Our Reference: SYD17/00407/01 (A17105200)
Council Ref: DA-2017/0097

CONSTRUCTION OF CHILDCARE CENTRE – 368-376 PITTWATER ROAD, NORTH MANLY

Reference is made to Council's email dated 27 July 2017, regarding the abovementioned Application which was referred to Roads and Maritime Services (Roads and Maritime) for comment in accordance with the *State Environmental Planning Policy (Infrastructure) 2007* and for concurrence under *Section 138* of the *Roads Act 1993*.

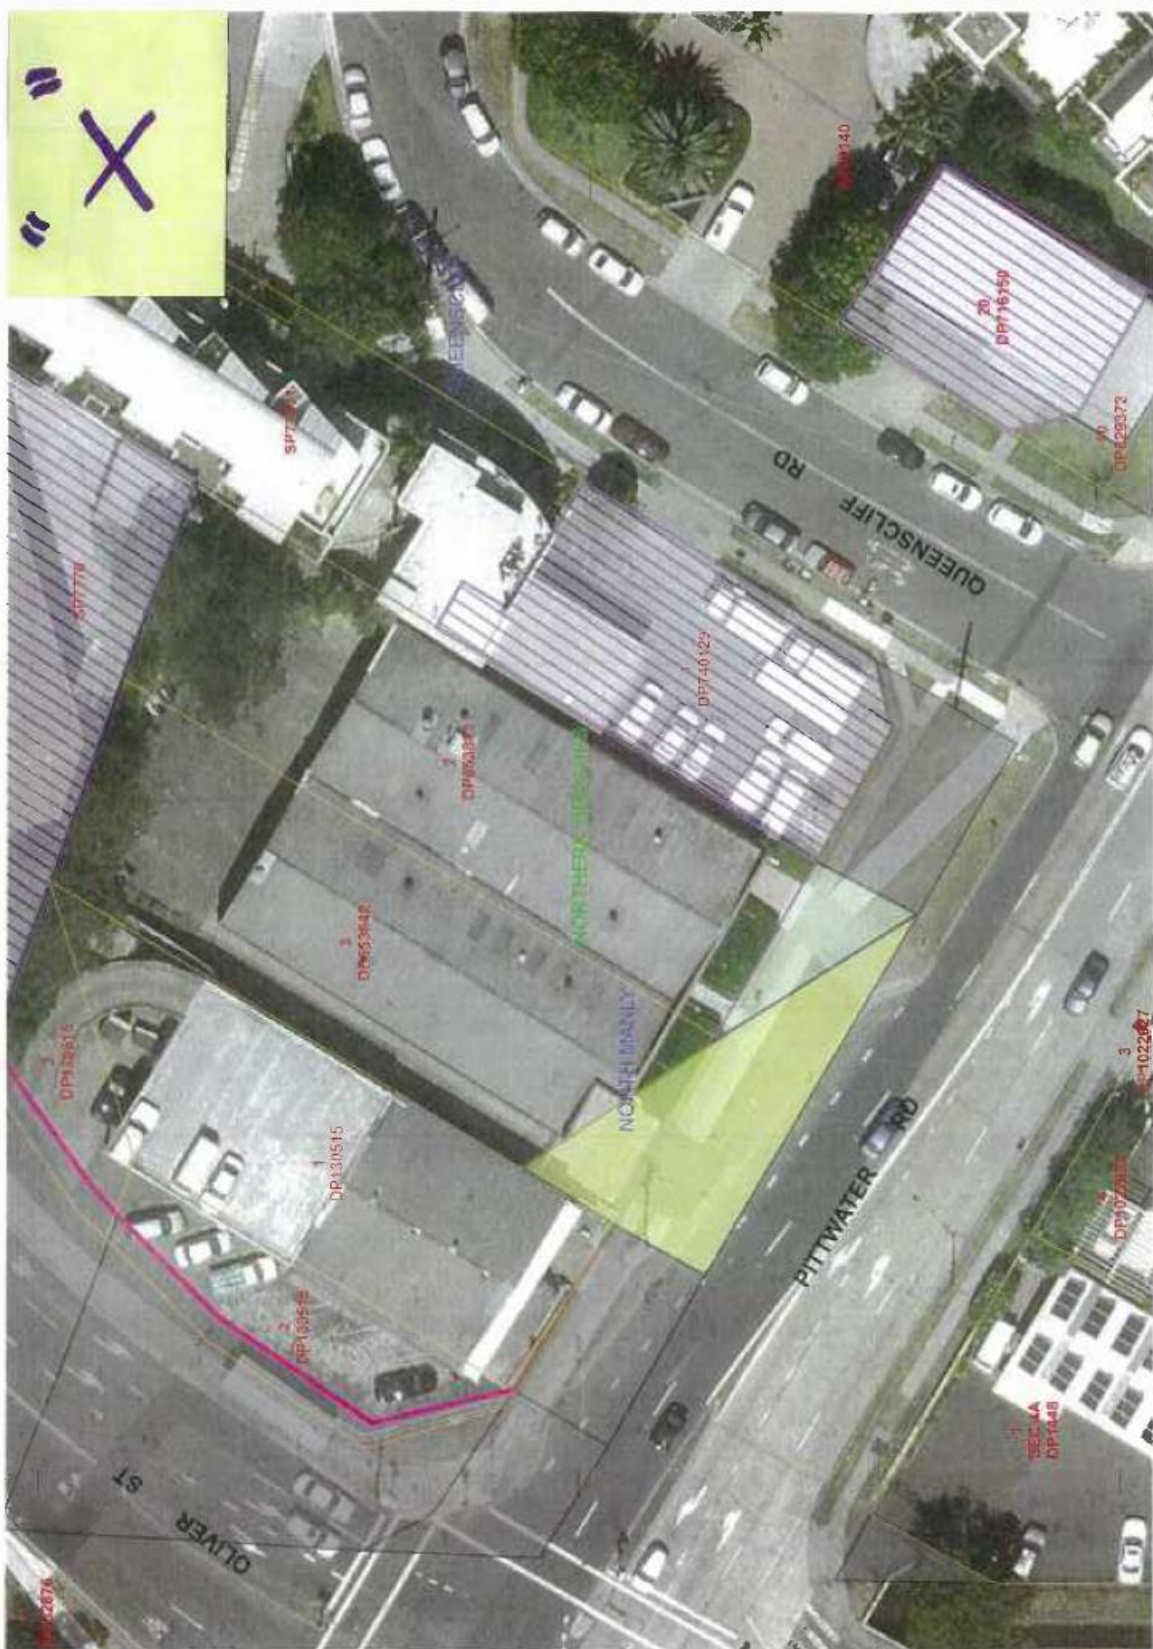
1. Roads and Maritime has acquired a strip of land for road along the Pittwater Road frontage of the subject property, as shown by green with blue edging on the attached Aerial – "X".

A strip of land has previously been dedicated as Public Road by Dealing B958566 along the Pittwater Road frontage of the subject property, as shown by yellow colour on the attached Aerial – "X".

Roads and Maritime has previously resumed and dedicated a strip of land as road along the Pittwater Road frontage of the subject property, as shown by grey colour on the attached Aerial – "X".

All buildings and structures, together with any improvements integral to the future use of the site are to be wholly within the freehold property (unlimited in height or depth), along the Pittwater Road boundary.
